Motor Retainer Upgrade Notice

IQSY TOMAHAWK Kit

REVISED LOCATION GUIDE

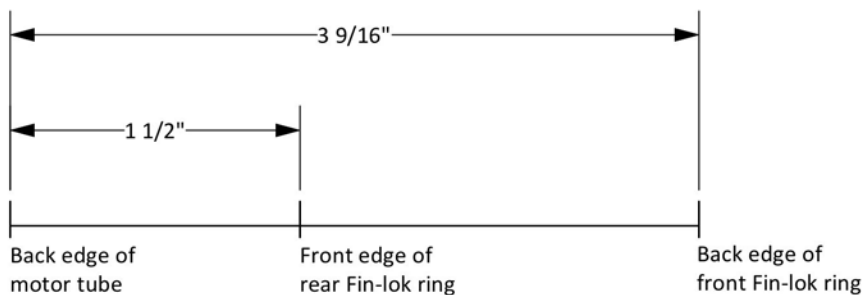
Use the **LOCATION GUIDE** above to make pencil marks along the motor tube line for location of the **FIN-LOK** rings per **STEP 3**. The new marks will move the motor tube rearward so that it is flush with the end of the body tube.

Follow **Step 1** of **FIN-LOK ASSEMBLY** using new location marks as above.
